To:	John Hamrick, Amory Quinn (Cotter Corporation, N.S.L.)	4109C
From:	Susan Wyman, P.E., P.G. (Whetstone)	
Date:	June 25, 2012	
Subject:	Response to DRMS Preliminary Adequacy Review of Technical Revision 20 (TR-20) for Grouting at the Schwartzwalder Mine (M1977-300)

Cotter Corporation (N.S.L.) (Cotter) submitted a Technical Revision to the Colorado Division of Reclamation, Mining and Safety (DRMS) on June 18, 2012, for installation of a grout curtain at the Schwartzwalder Mine. DRMS provided a preliminary adequacy review in a letter to Cotter dated June 25, 2012. The purpose of this technical memorandum is to respond to issues raised by DRMS in the preliminary adequacy review.

FIGURE 1
PROPOSED GROUTING AREA

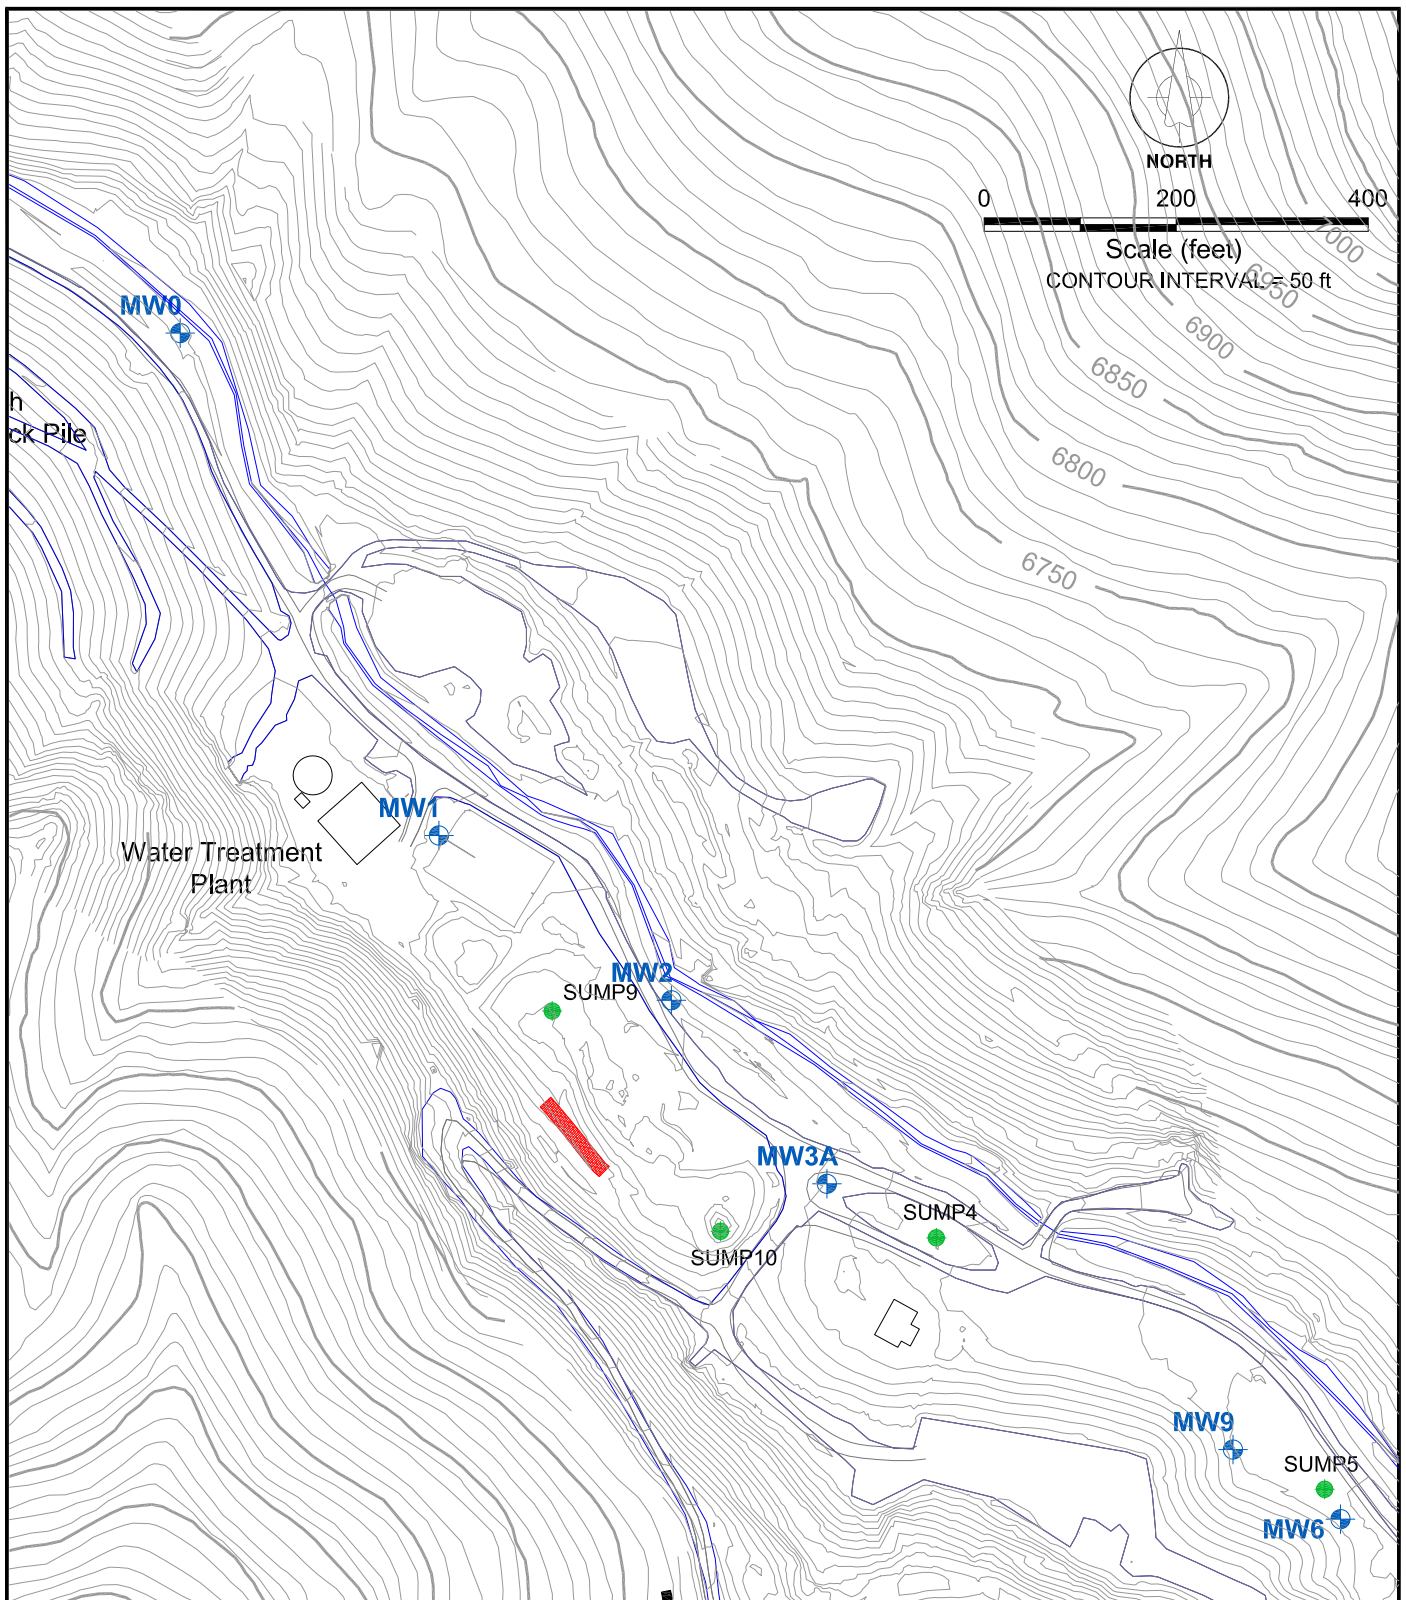
1. Please provide a map showing the outline of the grout curtain area.

A map showing the outline of grout curtain area is attached. The contour lines shown on the figure are approximate because earthwork was performed after the site was surveyed in May 2011.
